Comment Set D1 – Jack Horne

11 ***Re: SCE’s Comments on the Draft Environmental Impact Report (SCH #2015061014)***
12 ***for the Mesa 500 kV Substation Project (A.15-03-003)***

Response to Comment Set D1: Jack Horne

20
21 **A. Mitigation Measure Hydrology-6 Should Be Deleted Because The Mesa**
22 **Substation Site Is Not Within A Dam Inundation Area.**

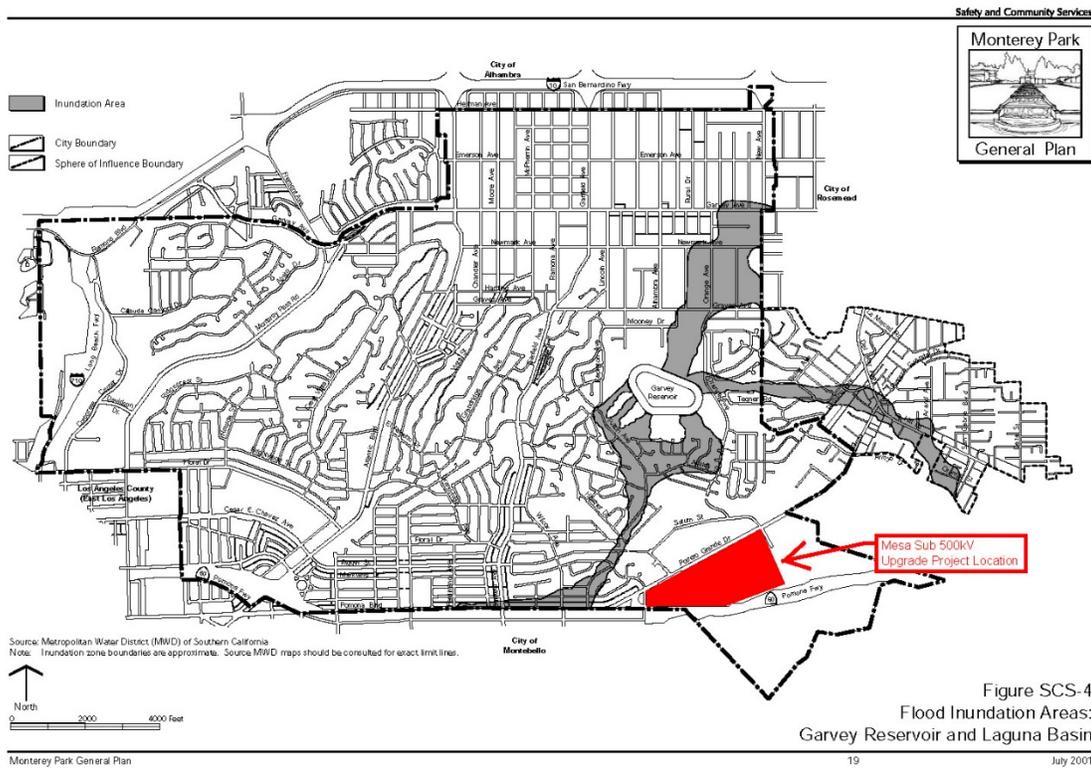
23
24 The DEIR erroneously concludes that the Mesa Substation site is located in a dam inundation
25 area.²⁸ Mitigation Measure Hydrology -6 (HY-6) would require SCE to install dam inundation
26 protection measures into the substation design, which could include a concrete perimeter wall
27 and flood gates at entry ways, elevation of substation equipment, and sealing equipment
28 buildings.

29 SCE reviewed the City of Monterey Park General Plan (2001) section related to the potential
30 failure of the north and south dams surrounding the Garvey Reservoir.²⁹ In particular, Figure
31 SCS-4 (Flood Inundation Area: Garvey Reservoir and Laguna Basin), shows the Main Project
32 Area is not within any inundation area as depicted in Figure SCS-4, showing the correct location
33 of the substation.

D1-29 SCE’s assertion that the proposed project is not within any dam inundation area as shown on the City of Monterey Park’s General Plan Figure SCS-4: Flood Inundation Areas: Garvey Reservoir and Laguna Basin is correct. The following corrections have been made to Section 4.8, “Hydrology and Water Quality,” of the Draft EIR to reflect this information.
